GTE/7
WP/04
09/03/09

**SEVENTH MEETING/WORKSHOP OF THE SCRUTINY WORKING GROUP
(GTE/7)**

**PROPOSED REVISIONS TO THE CARIBBEAN AND SOUTH AMERICAN RVSM GRUPO DE
TRABAJO DE ESCRUTINIO
(CAR/SAM RVSM GTE)**

This working paper presents a summary of proposed revisions to the CAR/SAM RVSM GTE Reference Guide.

Figure 1.

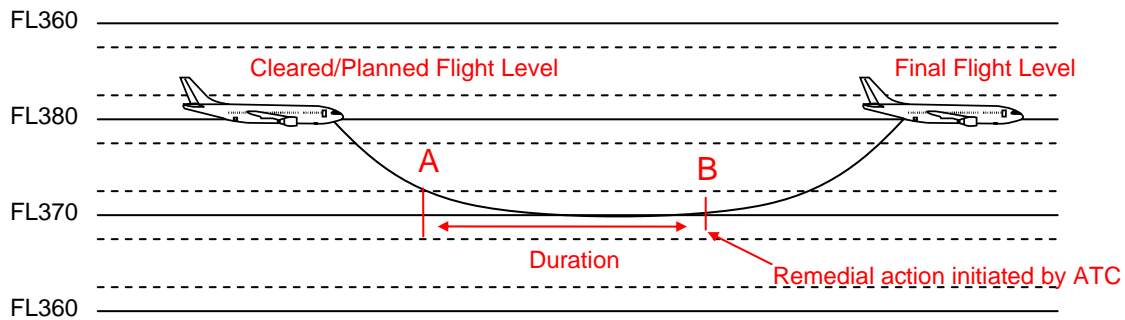
The line representing “A” in Figure one was modified to consider the buffer zone.

Figure 1 Three-minute Buffer Illustration

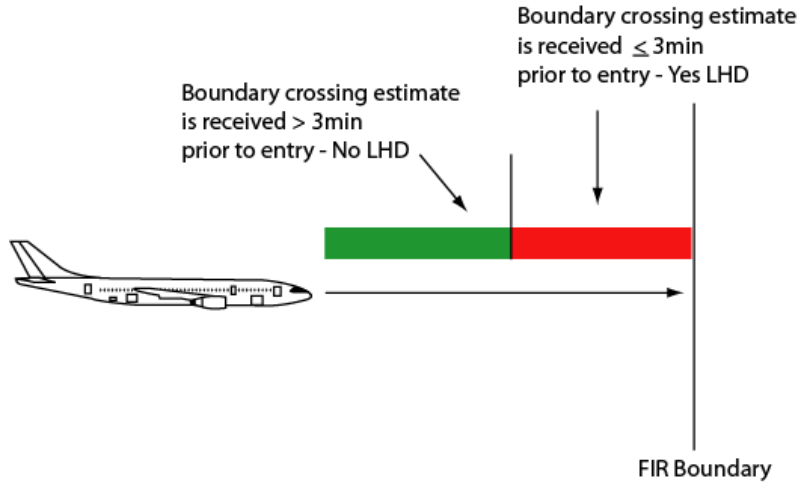
Interfacility Buffer Zone - A period of time used to determine whether a facility-to-facility coordination error should be considered a large height deviation. The current value established by the GTE is 3 minutes. In other words, if the boundary crossing estimate is provided before the agreed "buffer" duration then the event is not considered to be an LHD; if the estimate is received equal to or less than the established buffer estimate than the event is an LHD. The buffer value should be used as a guideline and each event should be evaluated individually. Figure 1 illustrates the "buffer" concept.

Diagram 1-A

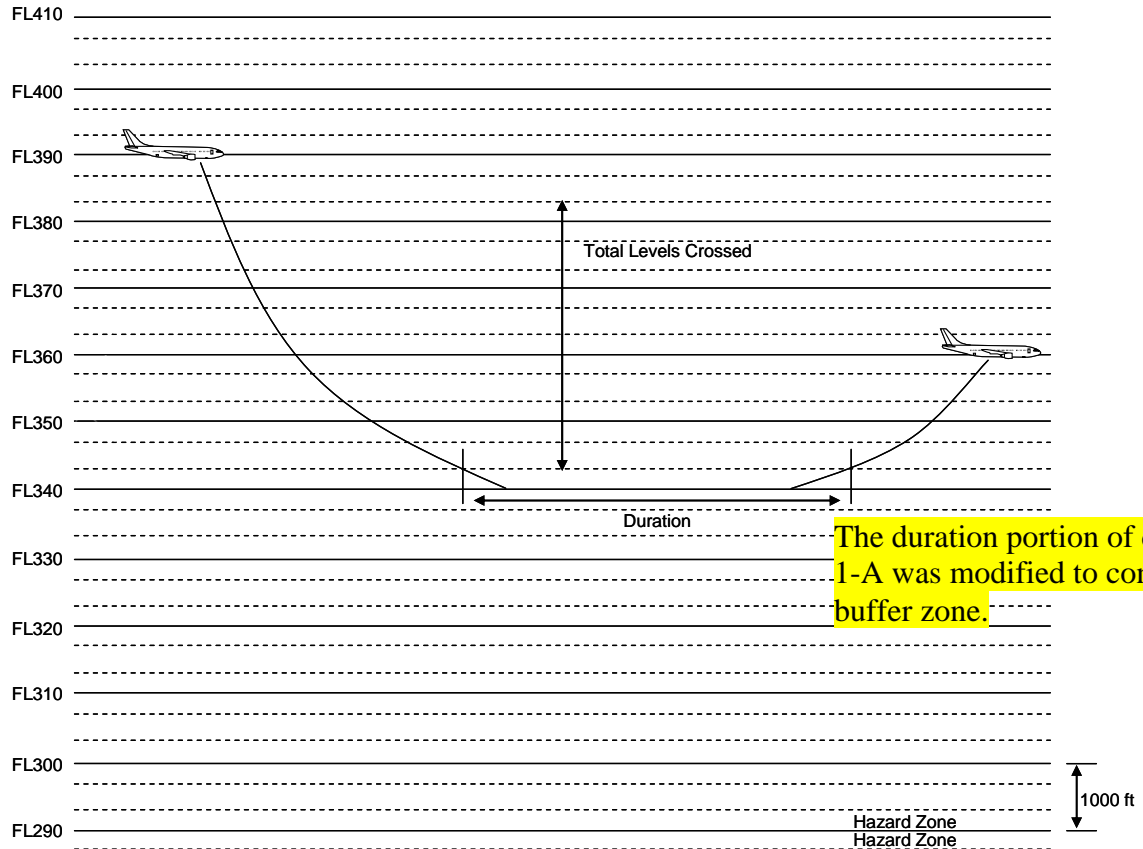
The duration portion of diagram 1-A was modified to consider the buffer zone.
